CONFIDENTIAL
PLANNING & DEVELOPMENT REPORT PD-042-20

RE: Teedon Pit Extension – Aggregate Resources Act Application
CRH Canada Group Inc.
North Part of Lot 80, Concession 1 O.S.
2 Darby Road – Roll #1-029-00 (Appendix 1)
Our File No. '19/D05 (DS #62762)

RE: Review of updated ARA Site Plans, dated September 2020, for Proposed Teedon Pit Extension, Township of Tiny

**Re: Teedon Pit Extension
CRH Canada Update Site Plans
Township of Tiny, County of Simcoe, Ontario
Project No.: 300031221.0000**

FOREST EDGE MANAGEMENT SCHEMATIC

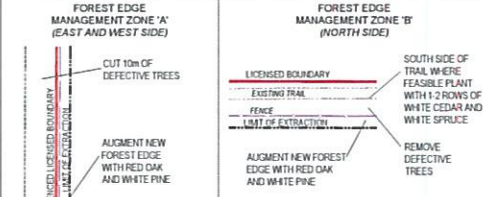
- Revising the Operational Plan to add a note to the Forest Edge Management Schematic: "The proposed forest edge management measures within forest edge management zones 'A' AND 'B' will commence within three (3) years of the license issuance."

- Revising the Operational Plan to add a note to the Forest Edge Management Schematic: "The proposed forest edge management measures within forest edge management zones 'A' AND 'B' will commence within three (3) years of the license issuance."

THE PROPOSED FOREST EDGE MANAGEMENT MEASURES WITHIN FOREST EDGE MANAGEMENT ZONES 'A' AND 'B' WILL COMMENCE WITHIN THREE (3) YEARS OF THE LICENCE ISSUANCE.

TREE PLANTING SCHEMATIC

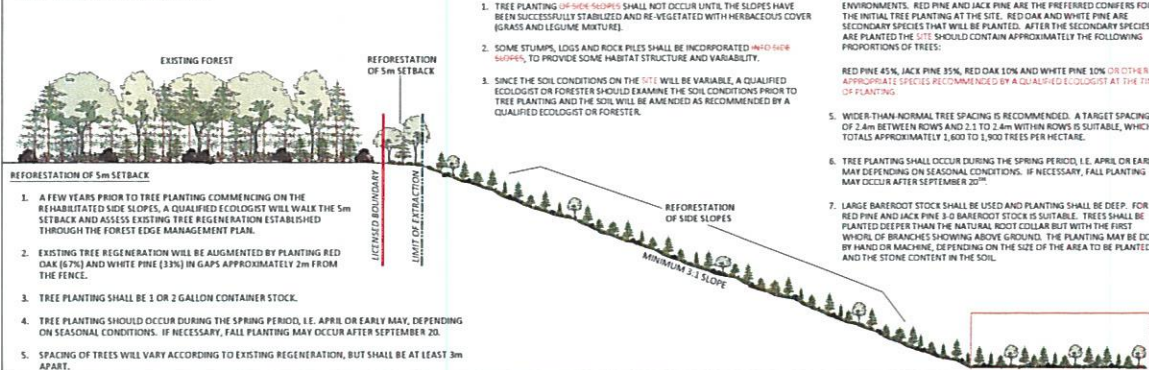
- Revising Note #4 on the Rehabilitation Plan to say "... or another appropriate species recommended by a qualified ecologist at the time of planting."

- Revising Note #7 on the Rehabilitation Plan to include survival assessment at year five (5) in addition to years one (1) and two (2), and that the note will be modified to require 60% survival of each species.

- Revising Note #4 on the Rehabilitation Plan to say "... or another appropriate species recommended by a qualified ecologist at the time of planting."

- Revising Note #7 on the Rehabilitation Plan to include survival assessment at year five (5) in addition to years one (1) and two (2), and that the note will be modified to require 60% survival of each species.

7. THE TREE PLANTING AREAS SHALL BE MONITORED FOR SURVIVAL IN THE FIRST AND SECOND AND EIGHTH YEARS AFTER PLANTING. REPLACEMENT PLANTING SHOULD BE UNDERTAKEN IF SURVIVAL OF EACH SPECIES IS LESS THAN 60%. IF HERBACEOUS COMPETITION IS PREVENTING TREE GROWTH / TREE SURVIVAL, A TENDING TREATMENT MAY BE NECESSARY (E.G. HERBICIDE APPLICATION BY A LICENSED PESTICIDE APPLICATOR).

- RED PINE 45%, JACK PINE 35%, RED OAK 10% AND WHITE PINE 10%. OTHER APPROPRIATE SPECIES RECOMMENDED BY A QUALIFIED ECOLOGIST AT THE TIME OF PLANTING.
